**STAGE 1 & 2
WORKPLANS**

Re: Plains Pipeline, L.P. C.S. Cayler (Plains SRS#2002-10250)
NMOC Reference # AP-052 (OLD 1R-0382)
UL-B (NW¼ of the NE¼) of Section 6, T17S, R37E
Latitude: 32° 52' 2.45"N and Longitude: 103° 17' 17.73"W
Landowner: Robert C. Rice
Lea County, New Mexico

C.S. Caylor (PLAIN044SPL)
SRS # 2002-10250
Lea County, New Mexico
Proposed Monitor Well Location

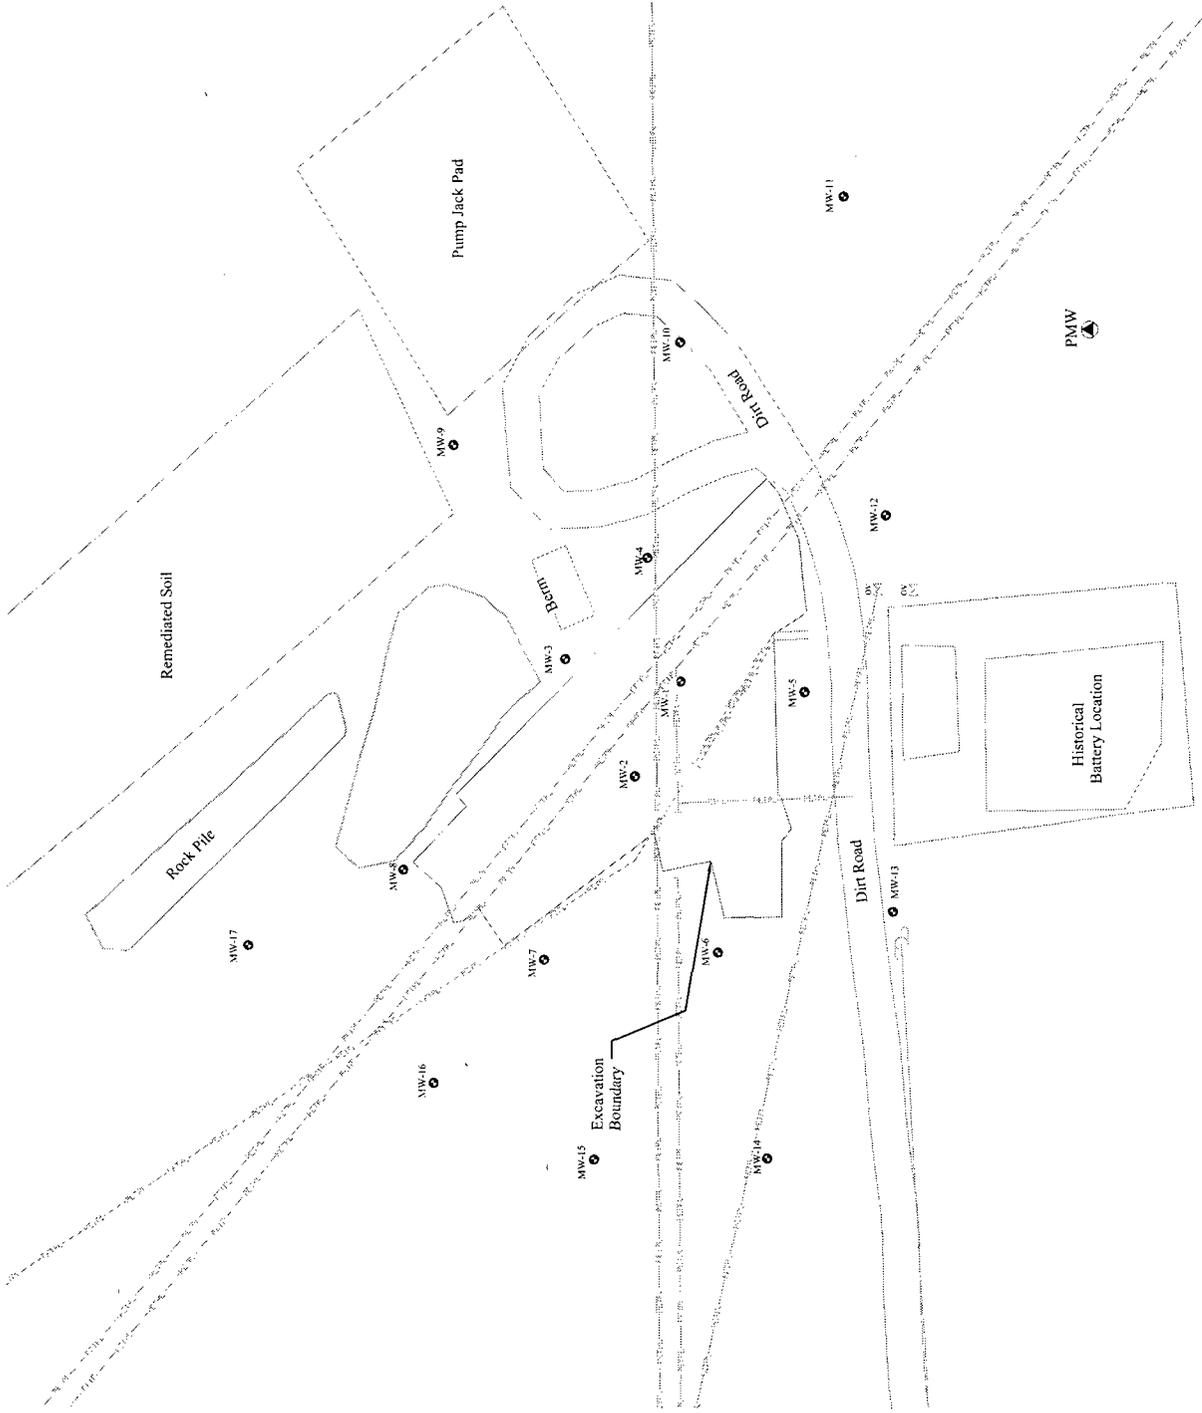
2. "The groundwater remediation program must specify that a more aggressive non-aqueous phase liquid (NAPL) removal program (which may include recovery wells). This must also include the method(s) for treatment and/or disposal of the oil and groundwater removed."

Response: Plains will install one monitor well southeast of monitor well MW-12 in March 2008, as requested by the OCD. Plains is experiencing on-going negotiation and logistical delays in their efforts to ascertain viable groundwater disposal options.
